AUTUMNDALE SUBDIVISION, RESUBDIVISION OF **LOTS 100-102**

APPLICATION NUMBER 4 DATE March 5, 2009

REQUEST Subdivision

DETAIL SITE PLAN

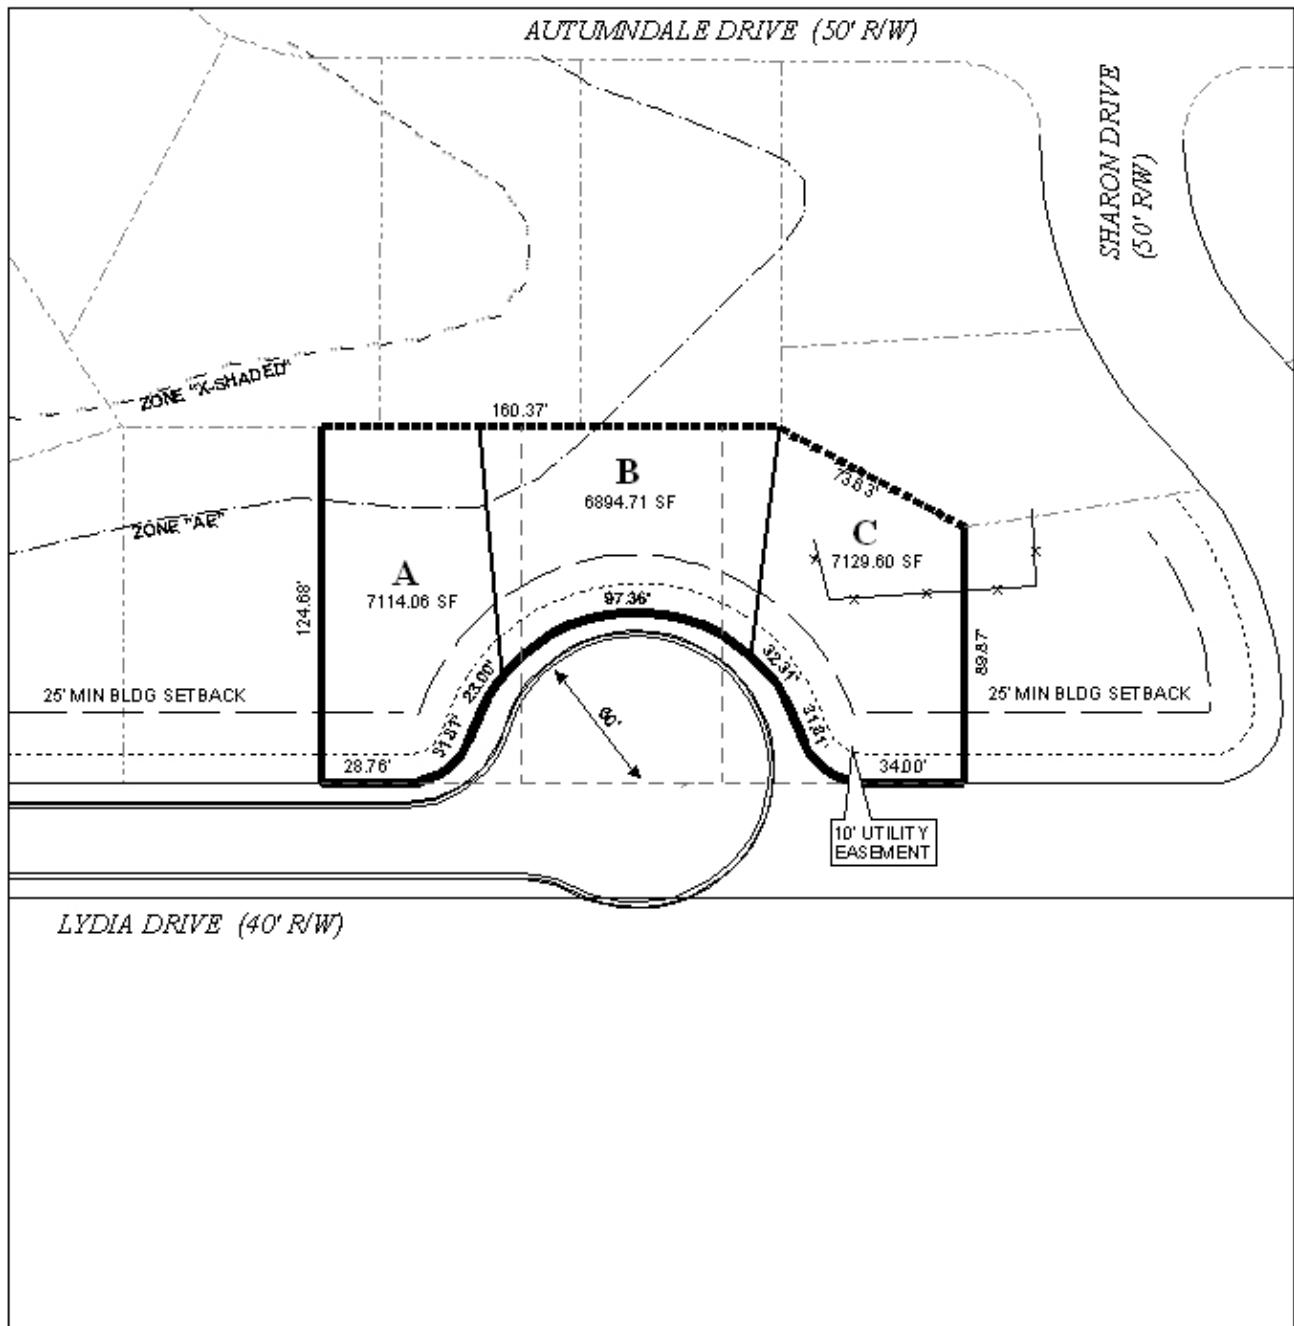
The plat illustrates Lydia Drive as having a 40-foot right-of-way. While this is accurate, the City of Mobile also owns a 50-foot wide strip of land abutting the South edge of the Lydia Drive right-of-way. The City of Mobile Real Estate office has advised that this land can be used as Lydia Drive right-of-way, effectively giving Lydia Drive a 90-foot right-of-way in this area. The cul-de-sac is designed in such a way as to take more land from the existing lots than is needed, and thus causes the lots to not meet the 7,200 square foot area requirement for lots under Section V.D.2 of the Subdivision Regulations. The applicant should revise the preliminary plat to reflect the actual Lydia Drive right-of-way and design the cul-de-sac so each of the three proposed lots will meet the lot size requirements.

- 1) Revision of the preliminary plat to reflect the actual Lydia Drive right-of-way of 90 feet and design the cul-de-sac so each of the three proposed lots will meet the lot size requirements.
